# SERVICE DIRECTIVE BULLETIN

SERVICE DIRECTIVE BULLETIN NO. 0132

Revision 1

1. SUBJECT: Clutch Handle Rigging
2. MODEL: F-28A, F-28C, F-28C-2, F-28C-2R, F-28F, F-28F-R, 280, 280C, 280F, 280FX
3. EFFECTIVITY: All Serial Numbers
4. BACKGROUND:

Figure 1 – Clutch Handle Stowed when Rigged Properly and Improperly

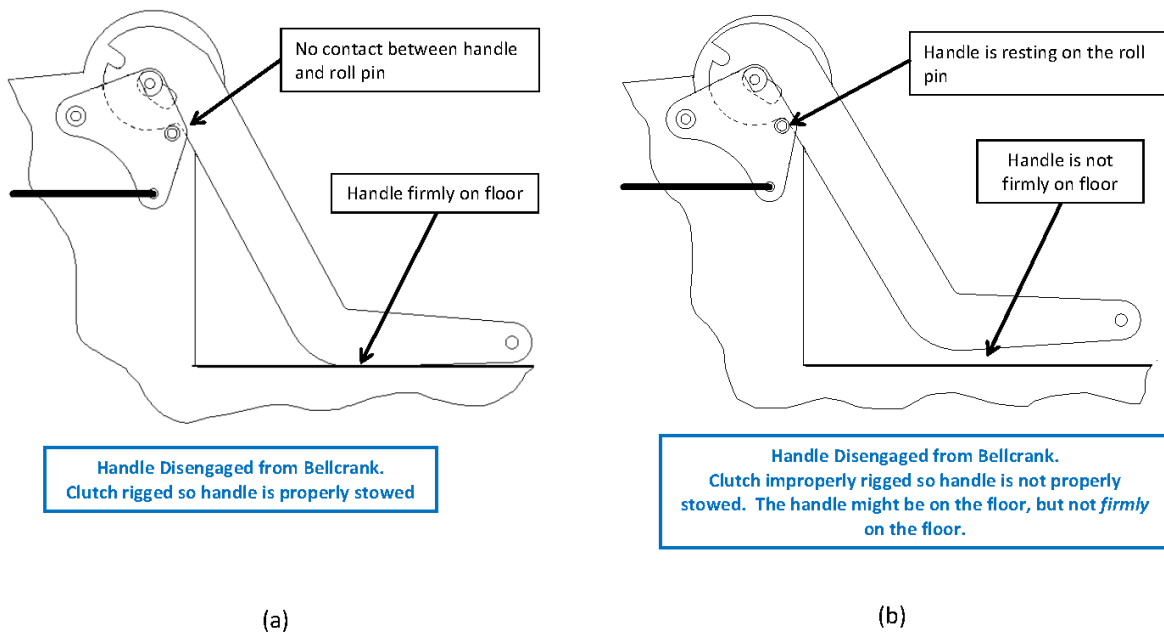
5.1.2 Verify the clutch handle is firmly on the floor as shown in Figure 1(a). Movement of the handle should have no effect on the P/N 28-16515-1 bellcrank.

5.1.4 If the handle rests on the floor, but not firmly, or if movement of the handle affects the bellcrank, the handle must be re-rigged in accordance with paragraph 5.2 before returning the aircraft to service.

5.1.3 If the handle rests firmly on the floor and movement of the handle does not affect the bellcrank, the aircraft may be returned to service until the next 100-hour or annual inspection.

Figure 2. Space Between the Lever and the Roll Pin

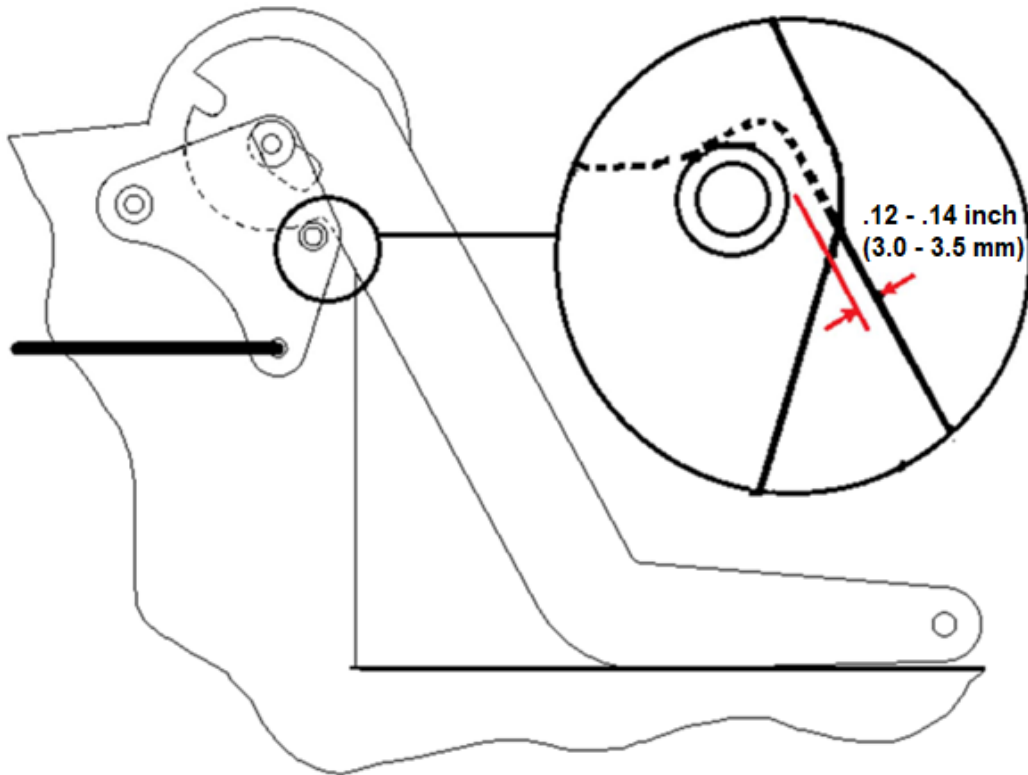
5.2.1.3 Use the shank of a 1/8-inch drill bit or a #30 drill bit to verify there is approximately .125-inch (3.2 mm) space between the clutch lever and the roll pin in the bellcrank (Figure 2).

5.2.1.4 Adjust the turnbuckle (Item 3 in SIL0080 Figure 2-A) as required to obtain clearance.

5.2.1.5 Verify proper operation of the clutch and that the handle stows flat and firmly on the floor with approximately a .125 inch (3.2 mm) space between the lever and the roll pin.

Figure 3 – Handle Modification

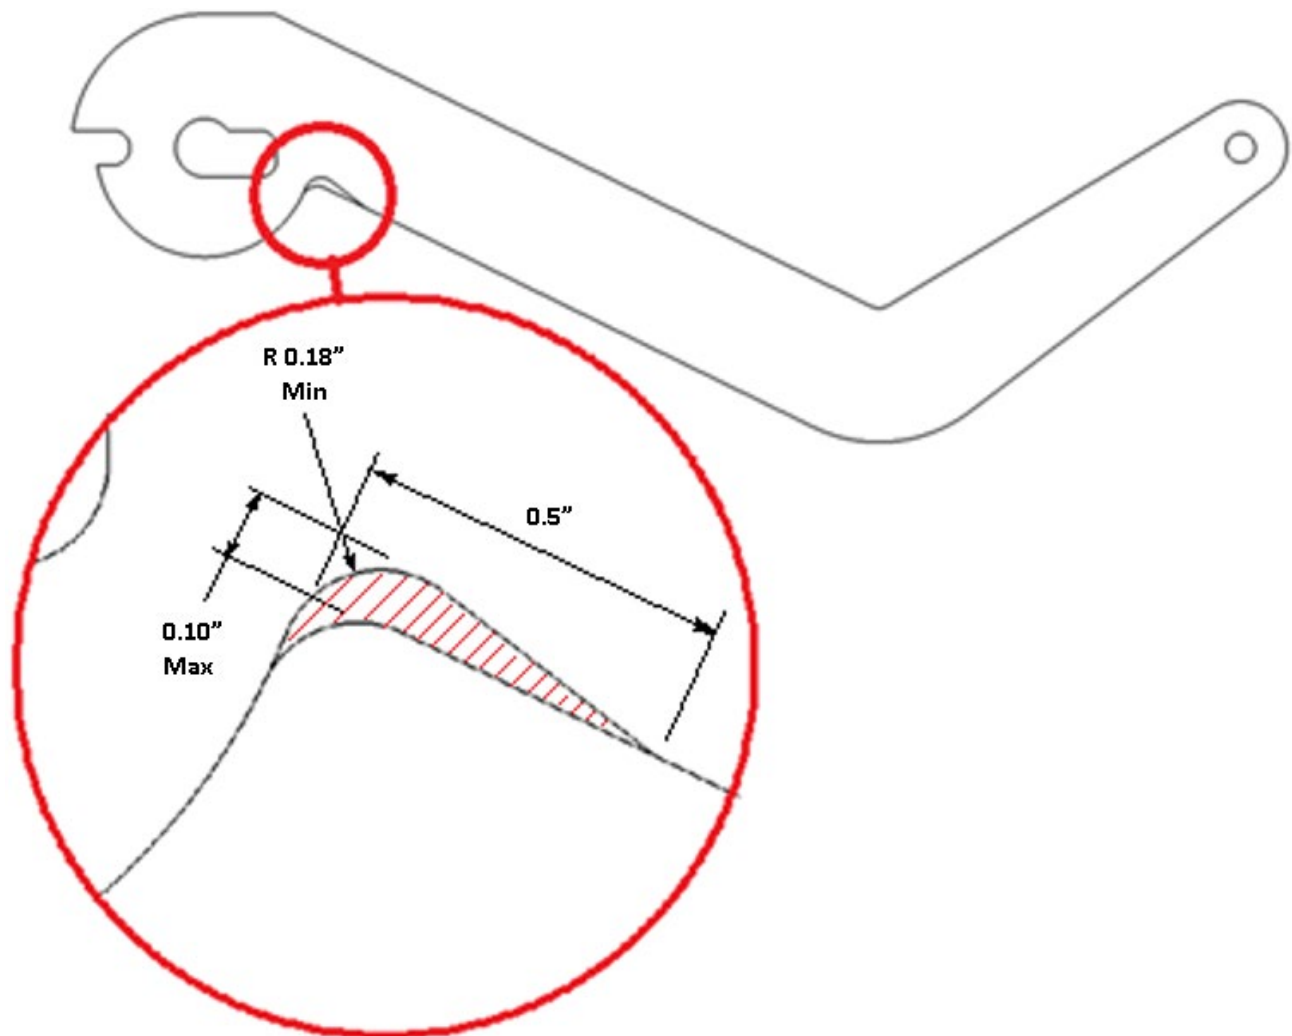
5.2.2 The lever may be modified as shown in Figure 3 to obtain more clearance if necessary.

5.2.2.1 Using a file or Dremel grinder or similar tool, remove material as shown in Figure 3.

5.2.2.2 Use fine sandpaper or similar abrasive to deburr the area and remove any tool marks.

5.2.2.3 Locally apply Alodine, Iridite, or equivalent conversion coating to the bare metal and paint the area black.
